PLANNING, ZONING, & BUILDING DEPARTMENT
PZ&B Staff Combination Memorandum: Architectural Commission and Town Council

SUBJECT: ZON-24-0093 (ARC-24-0128) 203 VIA VIZCAYA (COMBO)

MEETING: FEBRUARY 26, 2025 ARCOM
MARCH 05, 2025 TC

The applicant has submitted plans, entitled "PROPOSED NEW CONSTRUCTION: 203 VIA VIZCAYA" as prepared by **Solstice Planning and Architecture**, uploaded February 10, 2025.

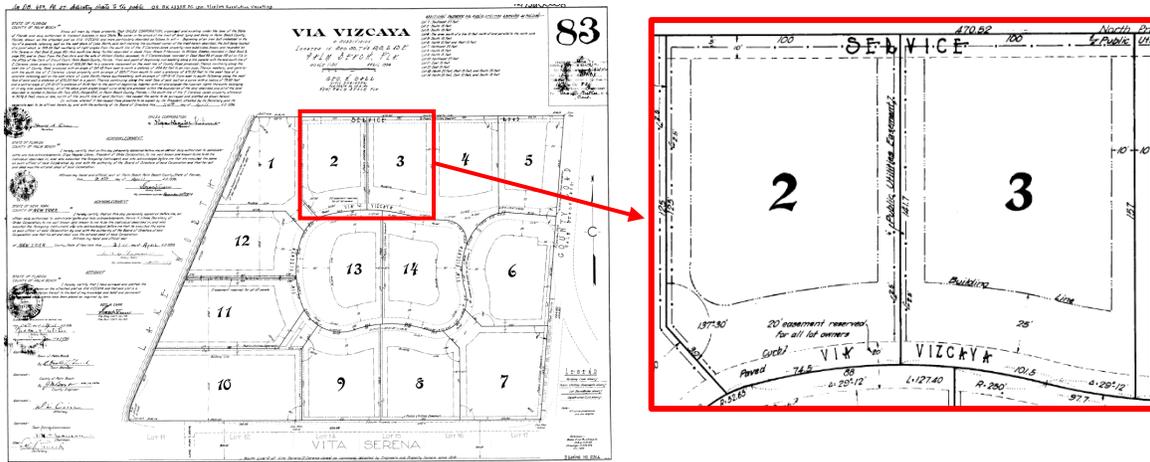
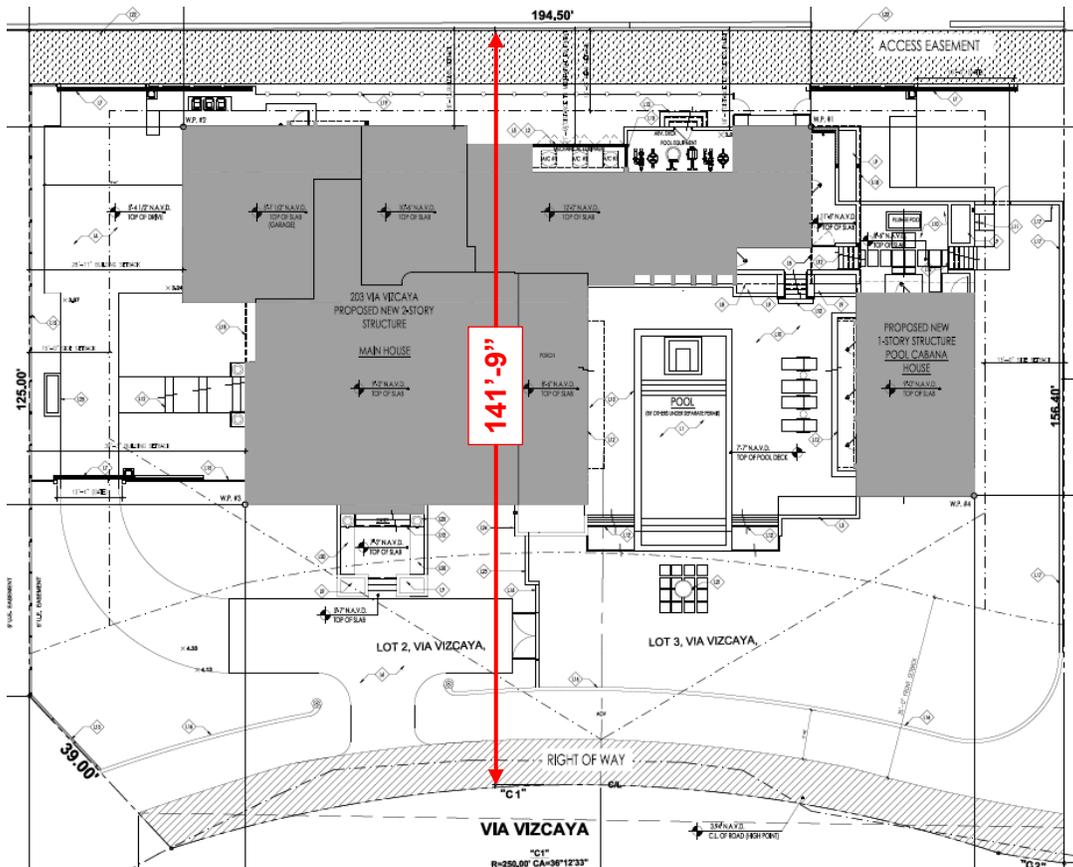
The application requires one Special Exception with Site Plan Review and one variance as designed. The need for a Special Exception stems from the existing configuration of the lot. The town's code prescribes the calculation of lot depth as "the distance from the midpoint of the front lot line to the midpoint of the mean rear lot line". Following the definition, the lot depth is 141'-9"

in lieu of the 150' required. The code does allow redevelopment of existing nonconforming parcels via the approval of site plan review or special exception.

Because this parcel is comprised of portions of platted plats (Lots 2 & 3 of Via Vizcaya plat, less the East 5.5 feet of Lot 3), the special exception is required.

PVIOUS PAVING SERVICE DRIVE

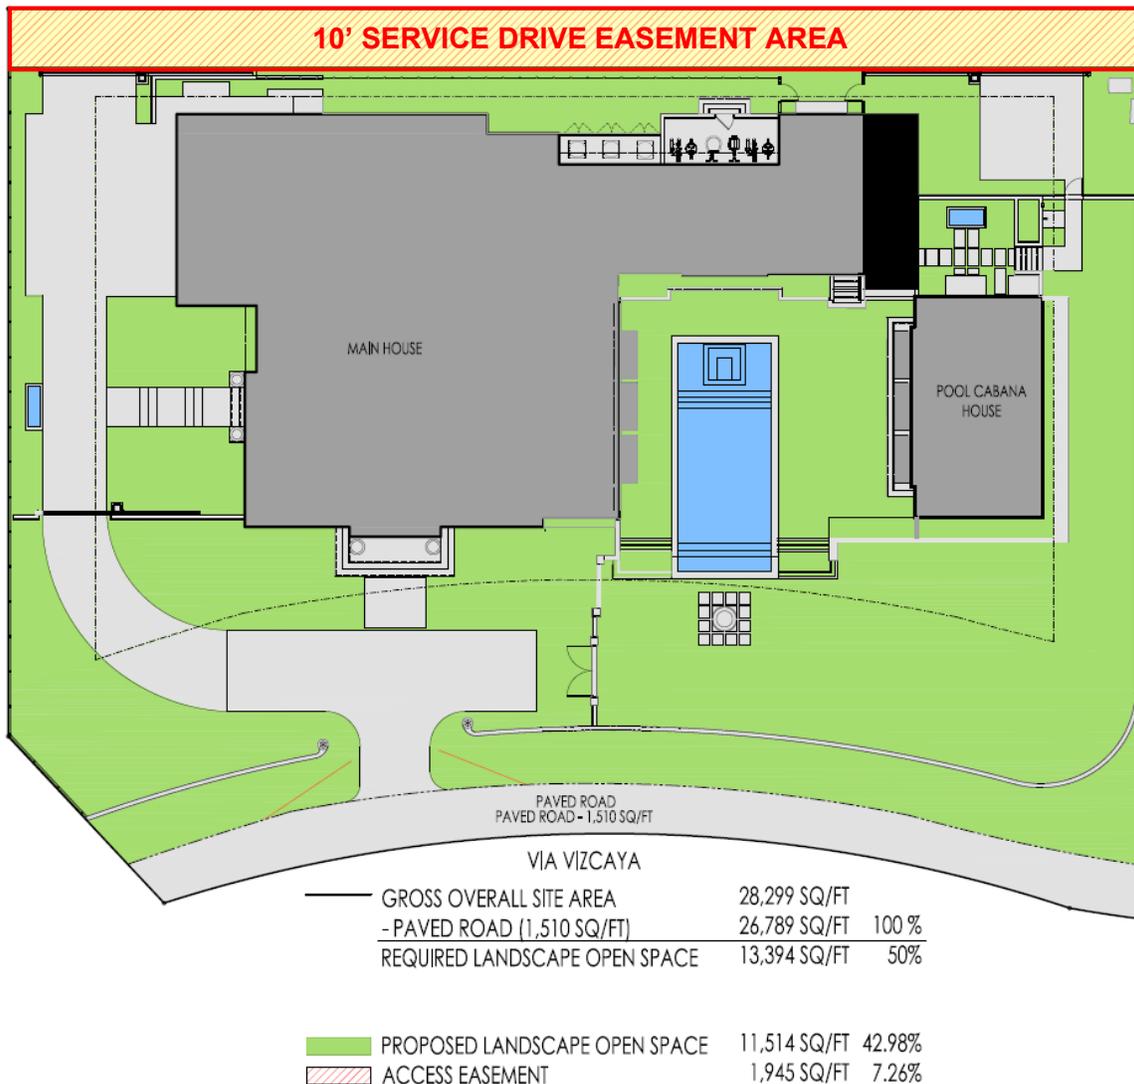
The variance requested is for reduced landscape open space. As shown on the survey, a 10'-0" wide "service road" easement existing along the northern span of the property. This easement begins at the parcel to the east of the subject parcel and provides access for the properties to the north and west. This area is included in the calculations when determining lot area, lot coverage and landscape open space. The applicant attests that if this area was not required to be included in the calculations, that the minimum landscape open space area of 50% would be met. The applicant does propose a pervious paver material across the service road in an effort to soften the effect of the variance.
